PEB Structure

For roof:-

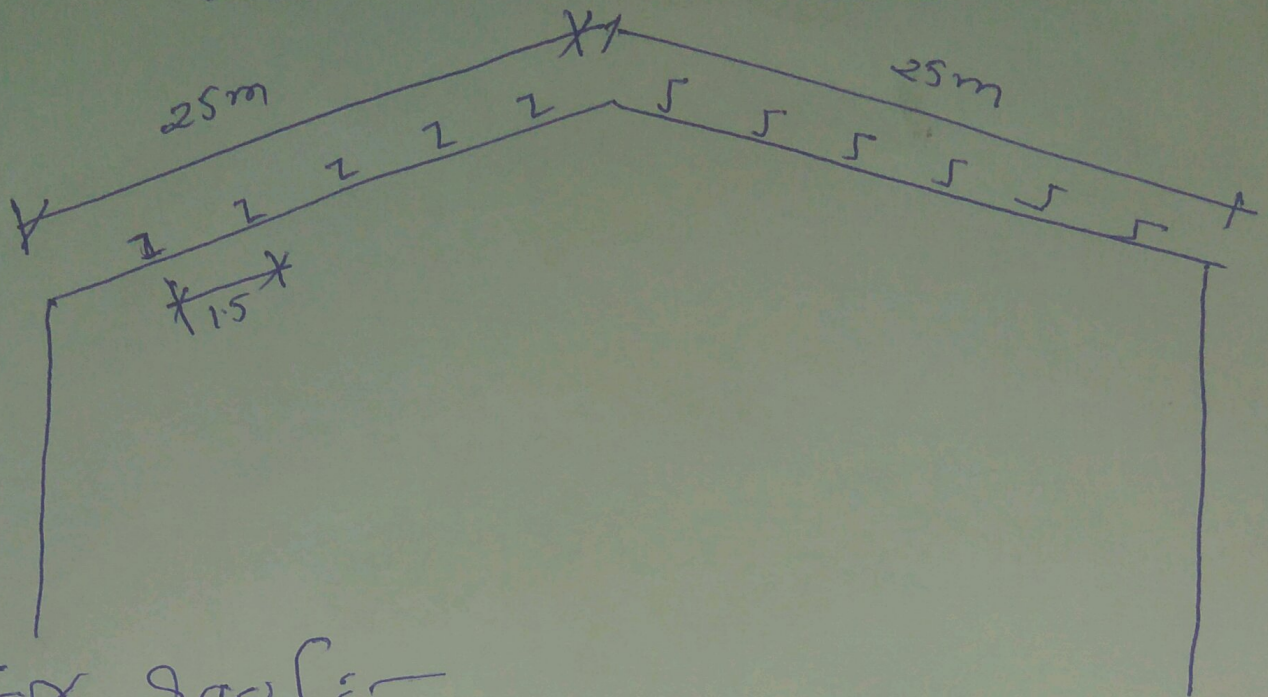
* As per PEB vendors design they have consider

$$l_y = 1.5m$$

$$l_z = 25m$$

* As per my thinking it should be $l_y = 1.5m$
 $l_z = 50m$.
